MURRAY CITY CENTER DISTRICT

2. The NOAH - 149, 155-157, and 163 East Vine Street

Project: 22-142

AGENDA ITEM # 2 - The NOAH

Figure 1: Area Indicated as C-1 "Private Sidewalk"

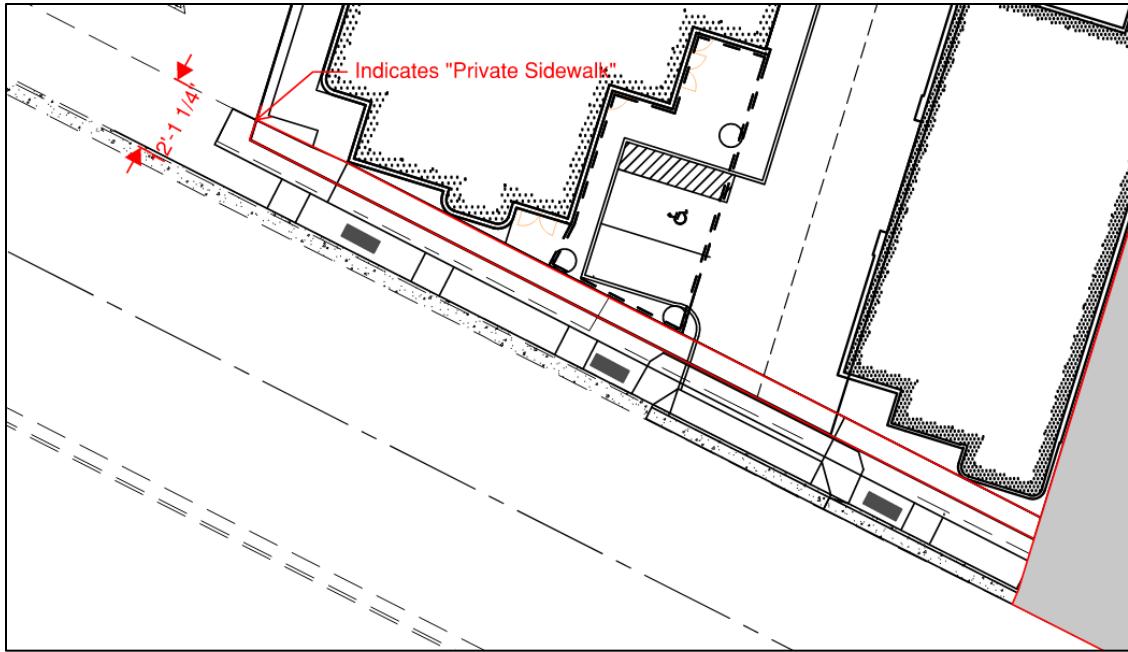
In preparation for this review, staff found a section of the improvements that were labeled as “C-1” on the Site Plan, the caption for this is “Private Sidewalk” (see figure 1 below). This will not be allowed in the MCCD Zone, the applicant will need to install the improvements and dedicate those improvements to the city as public right of way.

Planning Division staff is confident that the concerns mentioned above can be addressed between the MCCD Committee design review and the Planning Commission. They will be addressed as conditions of any design review recommendation.
